UNITED STATES
NUCLEAR REGULATORY COMMISSION
WASHINGTON, D.C. 20555-0001

SUBJECT: GENERAL ELECTRIC-HITACHI NUCLEAR ENERGY AMERICAS, LLC—
ISSUANCE OF AMENDMENT NO. 25 TO FACILITY LICENSE NO. R-33 FOR
THE NUCLEAR TEST REACTOR REGARDING RELEASE UNRESTRICTED
LAND (EPID NO. L-2019-PMP-0108)

SAFETY EVALUATION BY THE OFFICE OF NUCLEAR REACTOR REGULATION

GENERAL ELECTRIC-HITACHI NUCLEAR TEST REACTOR

Figure 1 - Diagram of proposed GEH site boundary

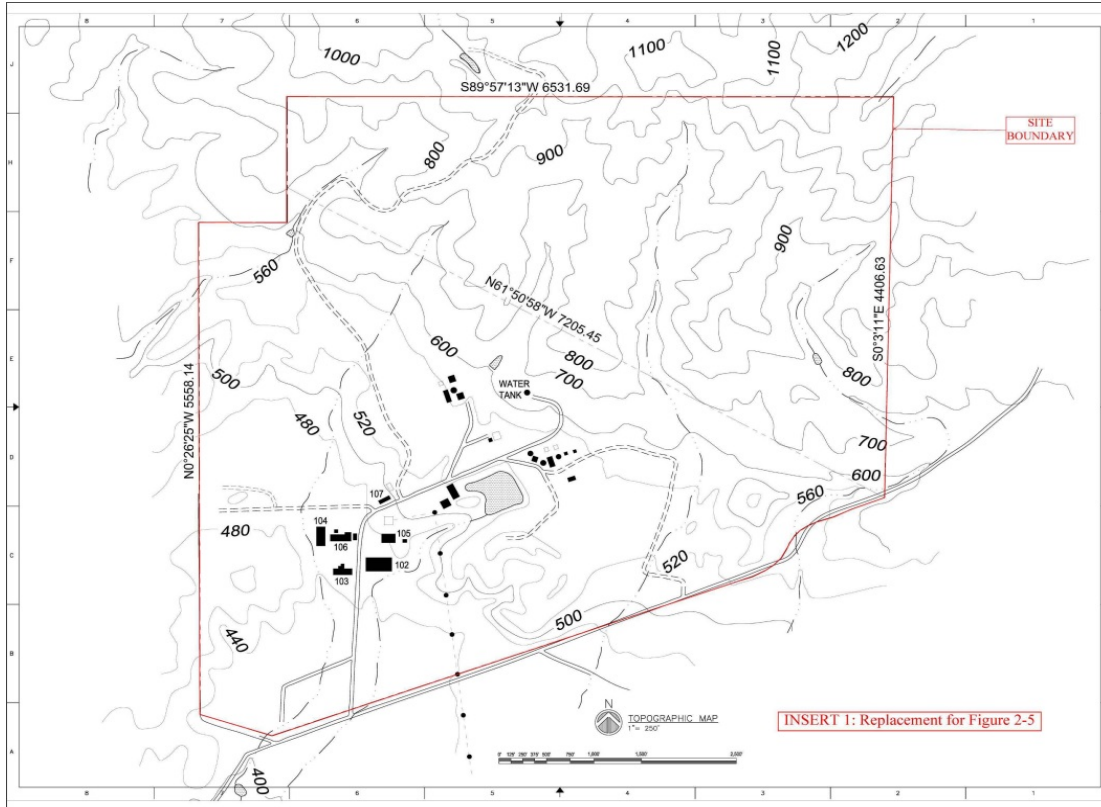
The VNC site is located at 6705 Vallecitos Road in Sunol, California. The VNC site is approximately 1,600 acres owned by GEH, located approximately 35 miles east-southeast of San Francisco, Alameda County, California. Figure 1 (Ref. 37) shows the overall VNC site boundary, which the licensee states is owned and operated by GEH. In its Request for Release of North Section of VNC Site (Ref. 34), the licensee stated that only 135 acres of the approximately 1,600-acre site is developed and used for the licensed activities of conducting nuclear power research, development, testing, and post irradiation examination of reactor fuel. The developed area is located within Area A shown on Figure 2 (Ref. 2). The combined acreage of Area A and Area B in Figure 2 is the same area shown as the proposed VNC site boundary shown in Figure 1. In Reference 37, the licensee proposes to replace Figure 2-5 in the NTR SAR with the diagram provided by Figure 1.

In the LAR, GEH proposes to change the definition of "Site" in TS 1.2.26 and in Section 2.0 "Site Characteristics" of the NTR SAR to eliminate the specific reference to the VNC site acreage. GEH also proposes to replace SAR Figure 2-5 "Topography Contour of Vallecitos Nuclear Center" with a diagram that clearly shows the VNC site boundary (Ref. 37). The proposed changes would allow the licensee to sell the released land to a non-GEH controlled entity. The licensee states that the current TS reference to "1600 acres" includes Area A (~400 acres), Area B (~570 acres) and Area C (~610 acres). Area B and Area C are outside the developed area for licensed operations of the four co-located reactor sites. According to the LAR (Ref. 1), Area B and C consist generally of undeveloped land, which is currently used for cattle grazing. The licensee also states that Area C has never been used for licensed activities. The LAR proposes no changes to Area B, which will continue to be retained by GEH.

Figure 2 - Overhead view of VNC Site Layout

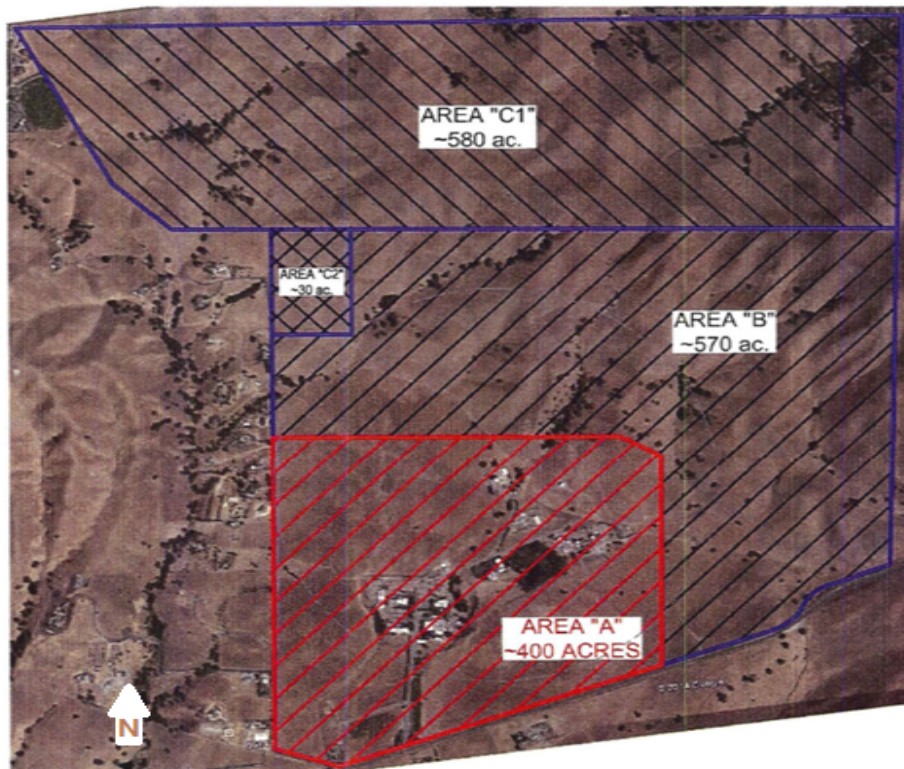
The VNC site has four co-located reactors on the site. The NTR, License No. R-33, is the only operating reactor on the VNC site, while two power reactors (the Vallecitos Boiling Water Reactor (VBWR), License No. DPR-1, and the Empire State Atomic Development Agency Vallecitos Experimental Superheat Reactor (EVESR), License No. DR-10) and one test reactor (GE Test Reactor (GETR), License No. TR 10) are currently in a SAFSTOR [Safe Storage] condition, in accordance with 10 CFR 50.82. All these facilities are located within Area A of Figure 2.

GEH previously requested to release the unused northern section of the VNC site (approximately 610 acres), shown as Area C1 and C2 in Figure 2, for unrestricted use (Ref. 34). Release of this land was approved on May 3, 2016, with respect to the VBWR (Docket No. 50-18), and the EVESR (Docket No. 50-183) under the 10 CFR 50.83, "Release of part of a power reactor facility or site for unrestricted use" (Refs. 22 and 25). As part of its review of the partial release, the NRC staff published an "Environmental assessment and finding of no significant impact" in the *Federal Register* on May 12, 2016 (Ref. 24), which concluded that a partial site release an approximately 610-acre parcel in the northern section of the approximately 1,600 acre VNC site for License Nos. DPR-1 (VBWR), R-33 (NTR), and DR-10 (EVESR), will not have any adverse environmental impact. Section 50.83 does not apply to the GEH NTR because it is a non-power reactor, but since the NTR is a research reactor and is co-located on the VNC site, the safety of releasing areas surrounding the NTR site were considered by the NRC staff in the partial release SE. The NRC staff confirmed by survey (Ref. 23) and inspection (Ref. 25) that the licensee correctly categorized the area as non-impacted.¹

In its LAR (Ref. 1), the licensee stated that, "The site acreage is not explicitly used in any of the analyses supporting the design and licensing basis of NTR." Additionally, because the land proposed for release (Area C of Figure 2) will still be owned by GEH until it is sold, but will not be part of the defined site boundary, the licensee proposed to further change the definition from "owned and operated" to "controlled" area to provide clarity (Ref. 37).
